AGENDA
REGULAR MEETING OF THE BIRMINGHAM PLANNING BOARD
WEDNESDAY JULY 13, 2022 – 7:30 PM
151 MARTIN ST., CITY COMMISSION ROOM 205, BIRMINGHAM MI*

SUBJECT: 460 N. Old Woodward – Wilders — Special Land Use Permit (SLUP), Final Site Plan & Design Review **(UPDATES IN BOLD BLUE TEXT)**

The applicant has submitted a Special Land Use Permit, Final Site Plan and Design Review application for a new bistro in the first floor tenant space of a new building planned in Downtown Birmingham. The subject site is located on the east side of N. Old Woodward, south of Ravine and across from Booth Park. On December 21, 2021, the Planning Board moved to approve a Final Site Plan and Design Review application for a new 3-story mixed-use building with minor conditions that have since been resolved. The proposed bistro is located in the first floor of the new 3-story building.

H5
A111
Enlarged
Outdoor Dining Plan
SCALE: 3/8" = 1'-0"

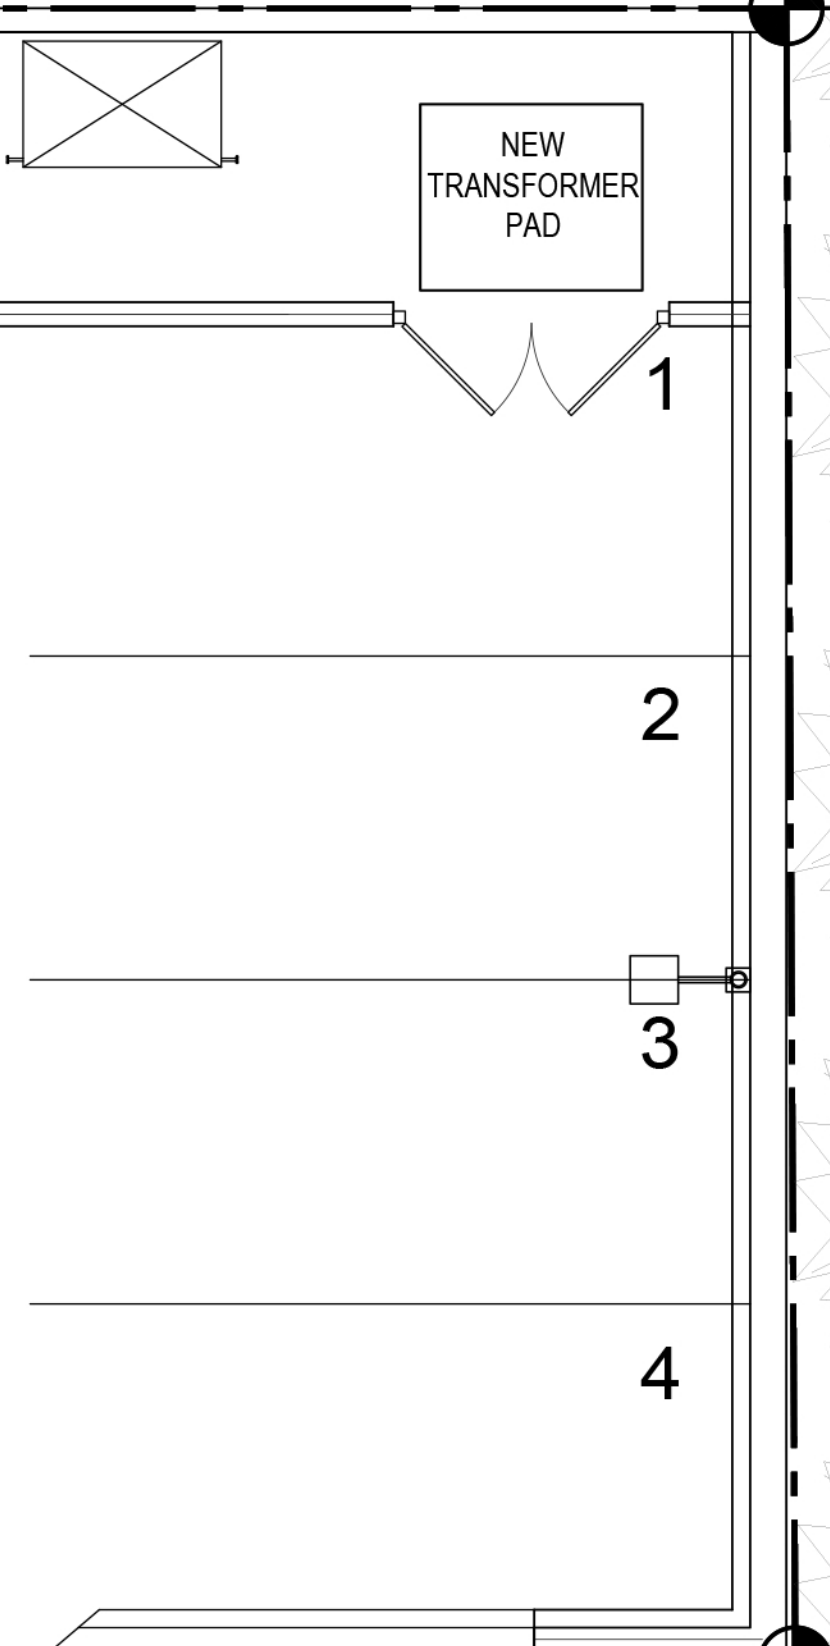
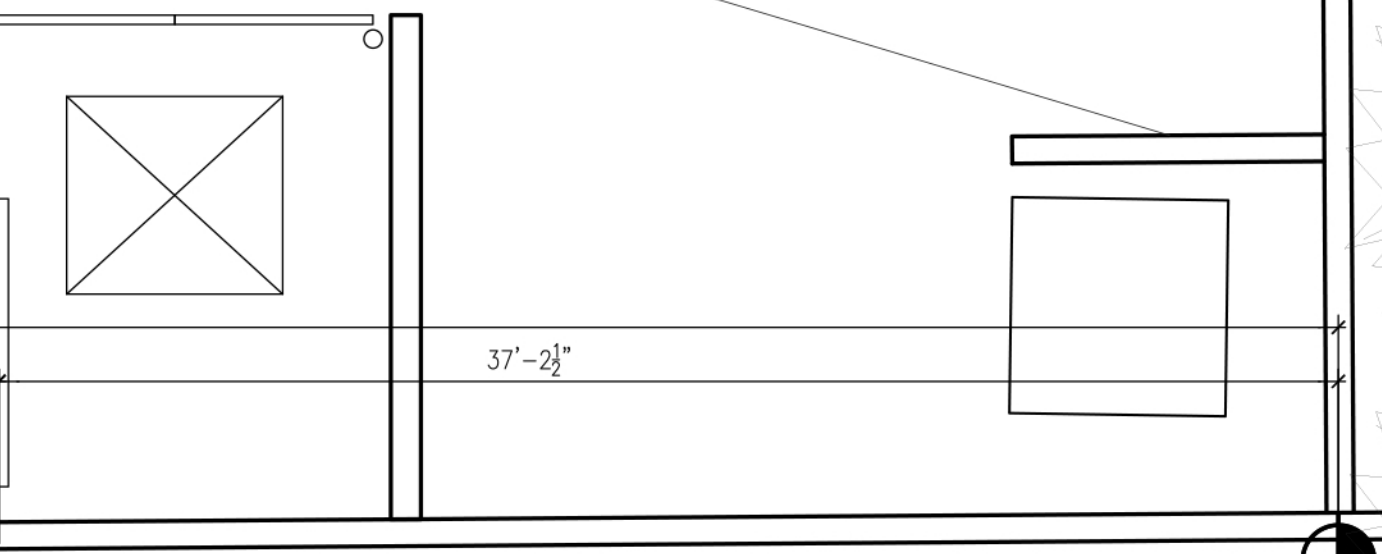
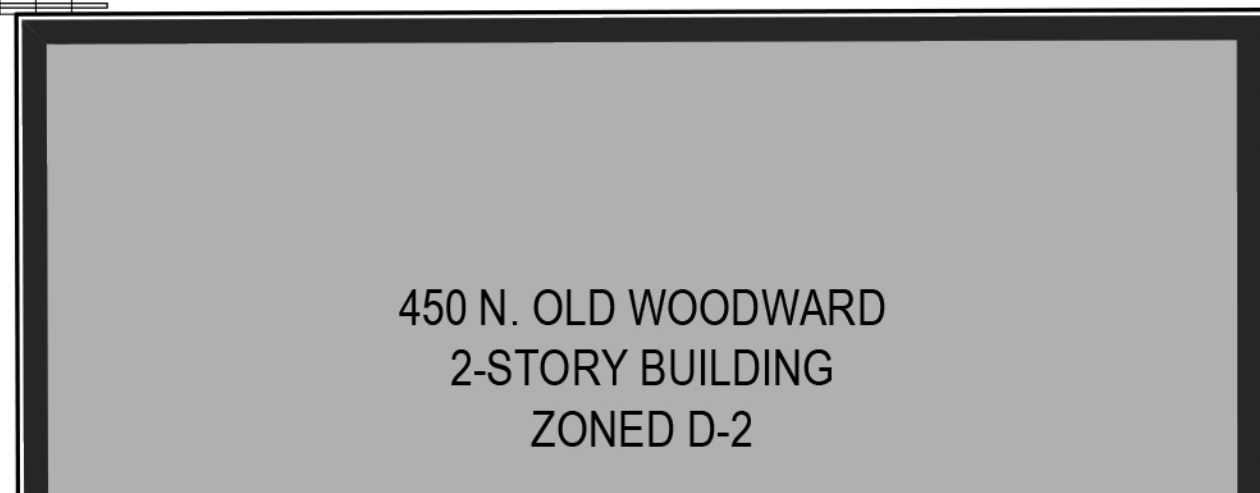
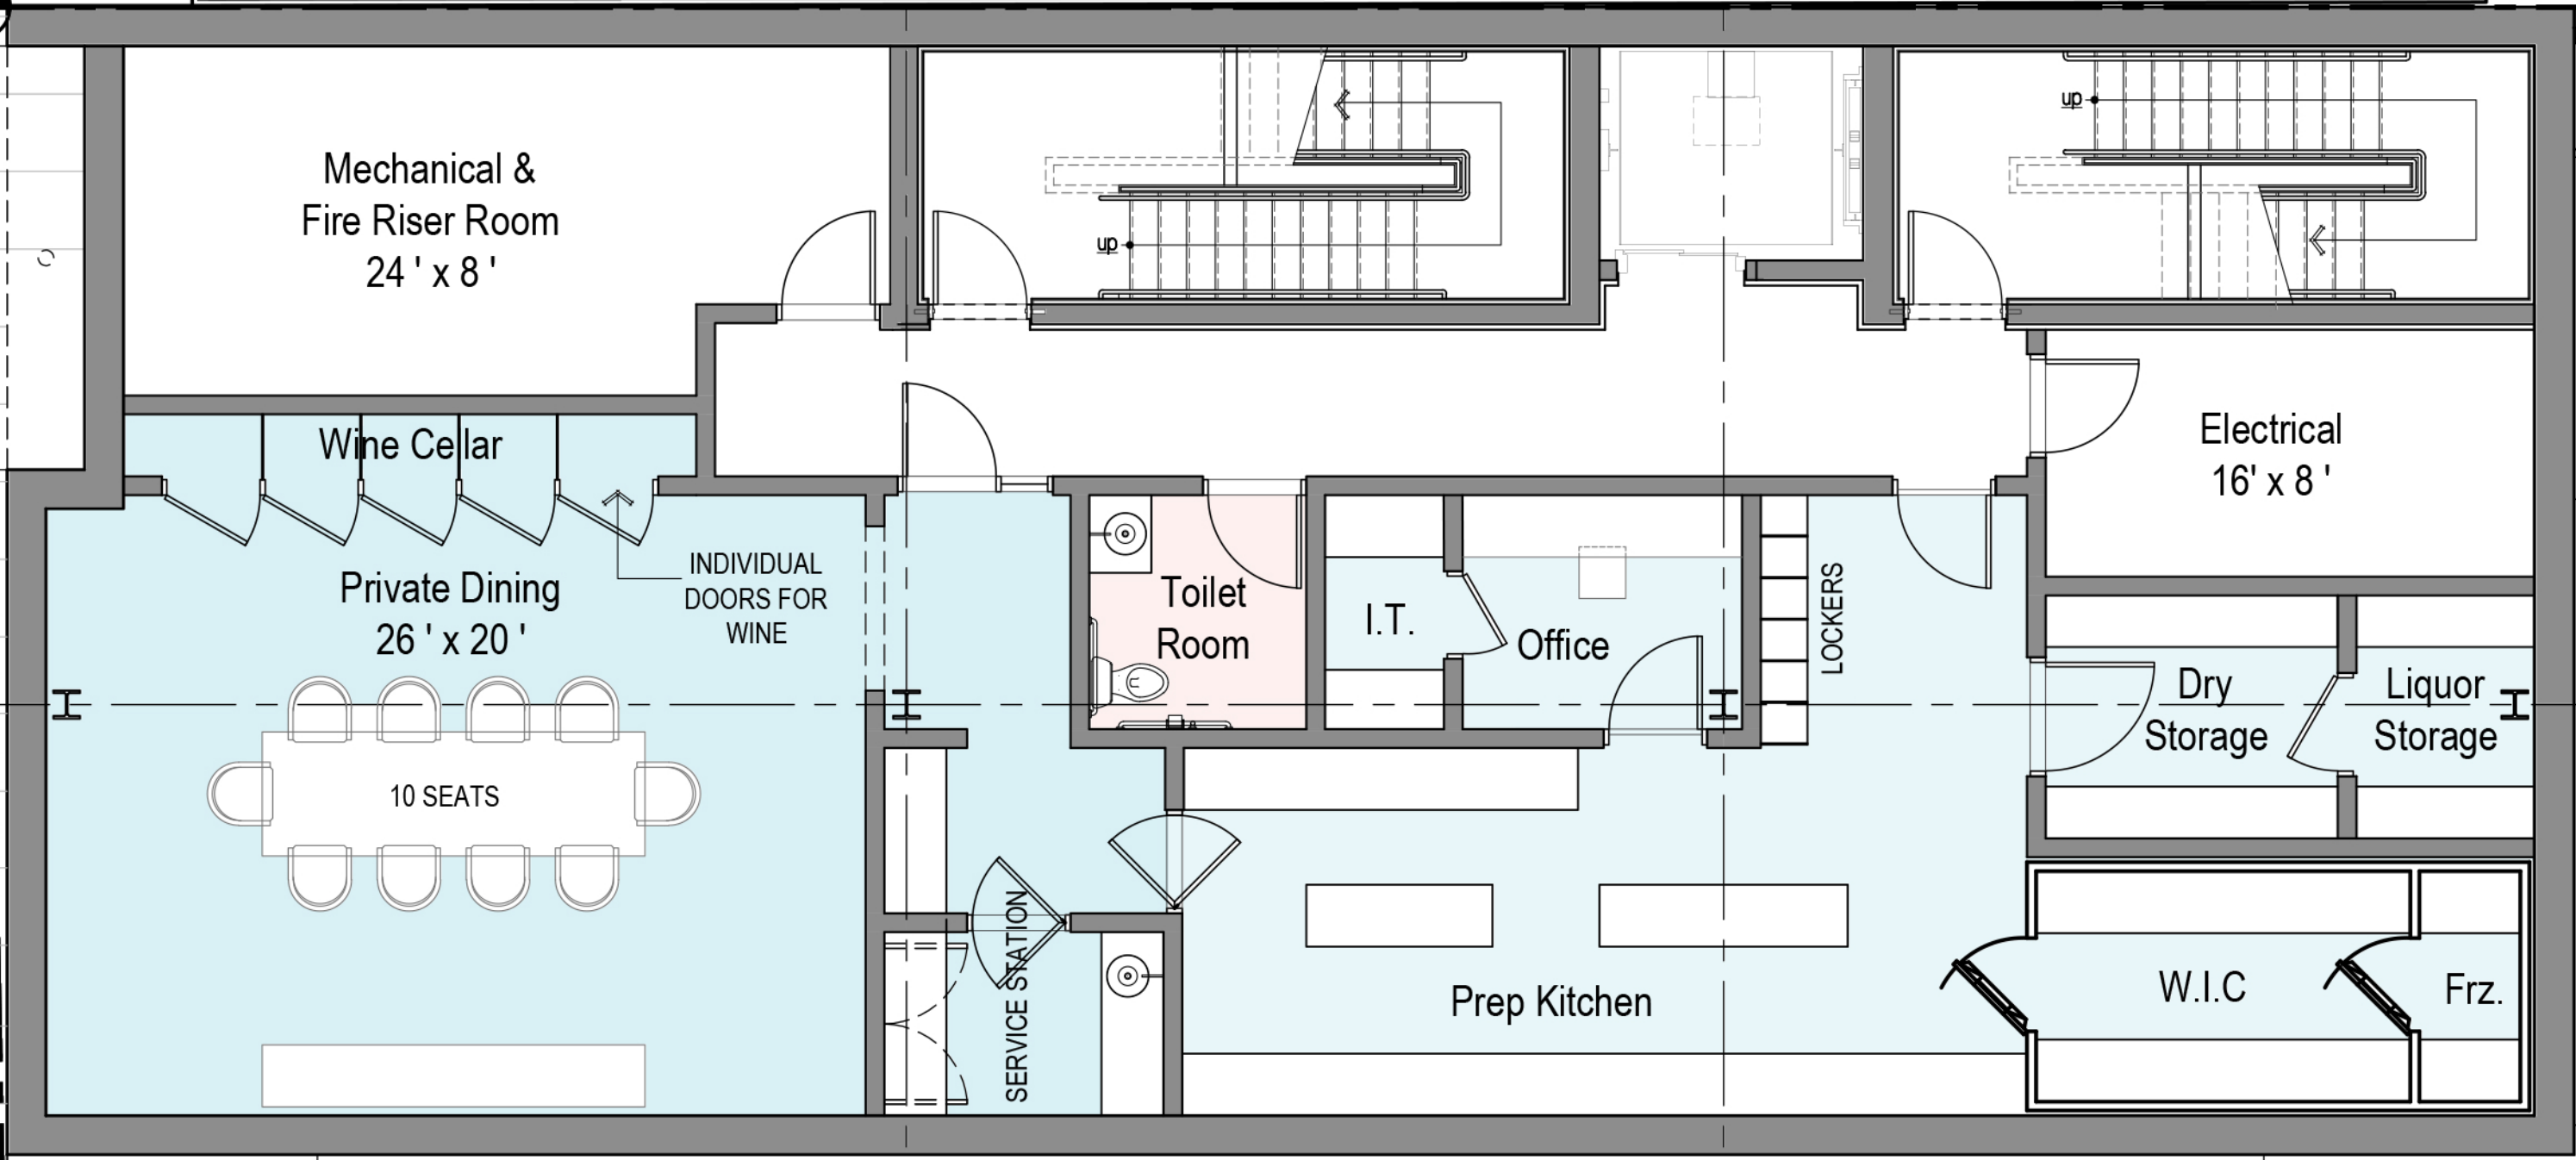
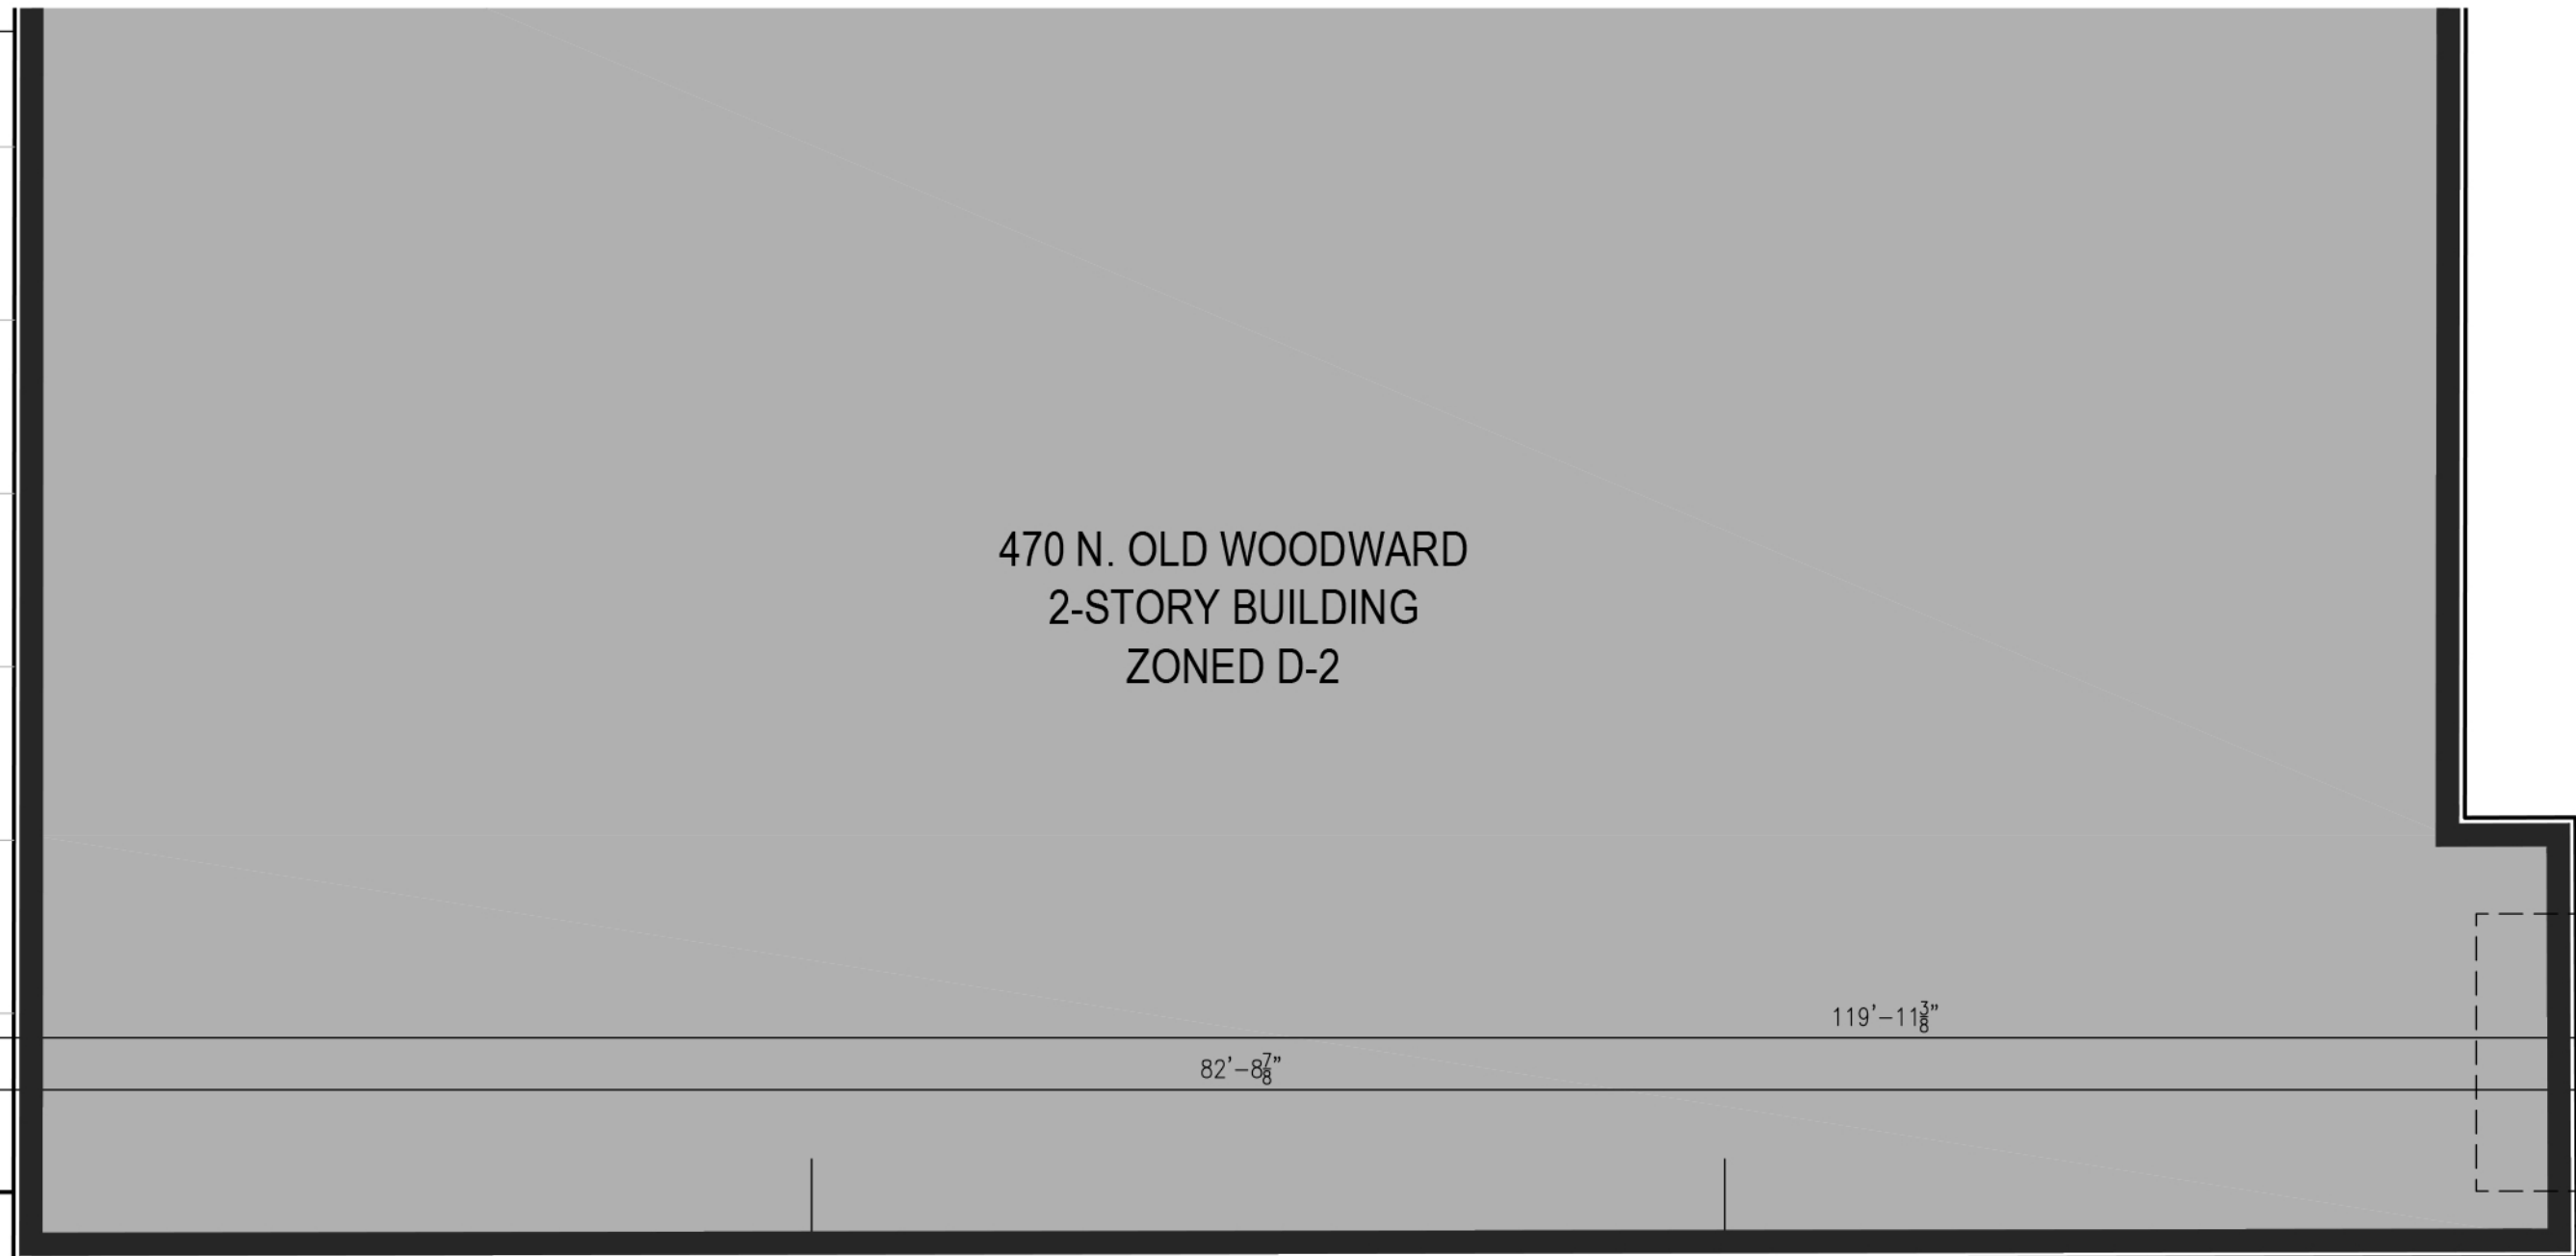
On June 22, 2022, the Planning Board moved to postpone consideration of the Special Land Use Permit, Final Site Plan and Design Review application citing concerns with the outdoor dining deck. The Planning Board requested a revised patio design that utilizes a portion of the street, as well as clarity on the proposed materials and fixtures of the platform. Please see the updates in the relevant sections below.

The applicant is proposing a 18-seat, roughly 270 sq. ft. outdoor dining platform located in the furnishing zone of the sidewalk located in front of the proposed bistro. The platform is split into two parts to accommodate an existing street tree, as well as the existing slope in the area. The platform is proposed to be enclosed with a metal railing with hanging planter boxes, and the platform will be enclosed with an aluminum surround. The applicant has also submitted details on potential table and chair options for the patio, which consist of an 'Option 1' and an 'Option 2'. The table options appear to be constructed of metal/high quality materials, and the chairs appear to be a wicker material, but it is unclear at this time. Thus, **the applicant must submit revised plans with the final table and chair selected for the patio, and must submit detailed specifications for both.**

Furthermore, the applicant has proposed a waste receptacle within the patio, but has not indicated whether or not the patio will contain other design or service elements such as umbrellas, service stations or the like. **The applicant must clarify and confirm the design of the patio to ensure that all outdoor dining elements have been considered as a part of this review.**

Based on the conversation at the Planning Board on June 22, 2022, the applicant has now submitted a revised patio design that is completely within the N. Old Woodward right-of-way and utilizes one public on-street parking space. The new platform contains 24 seats instead of 18 seats, which remains well under the maximum permitted of 65.

The proposed platform is trapezoidal in shape, and is constructed of trex decking that is flush with the curb. The applicant has also provided detailed information on all of the fixtures and furnishings proposed, which include aluminum railings, a service station, waste receptacle, fabric umbrellas, planter boxes, composite tables and wicker chairs. The tables and chairs appear to be constructed of high-quality materials as required.

Based on a review of the site plan submitted, the Planning Division recommends that the Planning Board recommend **APPROVAL** of the Special Land Use and Final Site Plan/Design Review application for 460 N. Old Woodward – Wilders – subject to the following conditions:

1. The applicant must submit revised sign plans that meet the requirements of the Sign Ordinance; and
2. The applicant must comply with the requests of all City Departments.
